# Access Compliance Report

## Public Rights-of-Way

### (Curb Ramps)

Intersection ID: 10041902	Main Street: WIND_CHIME_CT	Cross Street: N/A	Location: E
ADA ID: CC365249177C	Ramp Type: Perp	Initial Pass/Fail: Fail	Overall Compliance: No
Severity Score: 22.5			
Codes/Mitigation Info/Possible Solution		Field Measurements/Component Compliance

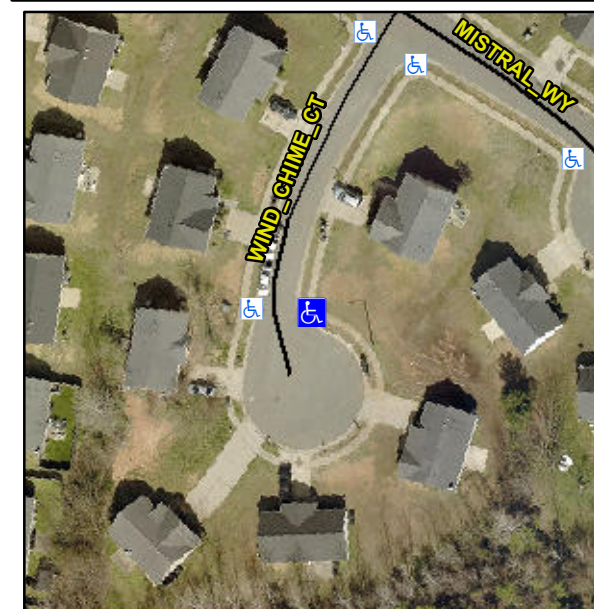
**Not Found, R304.5.1, R304.2.2**

Compliance	Description	Data	Compliance	Description	Data
N/A	Ramp Length (in)	48.0	No	Ramp Slope (%)	9.2
No	Ramp Width (in)	47.0	Yes	Ramp XSlope (%)	2.8
N/A	Flare Type LT	N/A	N/A	Flare Type RT	N/A
N/A	Flare Slope LT (%)	N/A	N/A	Flare Slope RT (%)	N/A
N/A	Flare Traversable LT?	N/A	N/A	Flare Traversable RT?	N/A
N/A	Landing Length (in)	N/A	N/A	DWS Provided?	N/A
N/A	Landing Width (in)	N/A	N/A	DWS Contrast?	N/A
N/A	Landing Slope (%)	N/A	N/A	DWS Length (in)	N/A
N/A	Landing X Slope (%)	N/A	N/A	DWS Full Width?	N/A
N/A	Landing Curb? (Y/N)	N/A	N/A	DWS Offset (in)	N/A
N/A	Shared Landing?	N/A			
N/A	Gutter Ponding?	N/A	N/A	Gutter Slope (%)	N/A
N/A	Gutter Lip Ht (in)	N/A	N/A	Gutter X Slope (%)	N/A
N/A	Painted X Walk1?	No	N/A	Painted X Walk2?	N/A
	X Walk 1 Direction	To W		X Walk 2 Direction	N/A
N/A	X Walk 1 Width (in)	N/A	N/A	X Walk 2 Width (in)	N/A
	X Walk 1 Slope (%)	1.1		X Walk 2 Slope (%)	N/A
	X Walk 1 X Slope (%)	3.8		X Walk 2 X Slope (%)	N/A

**Remove & Replace Entire Ramp.**
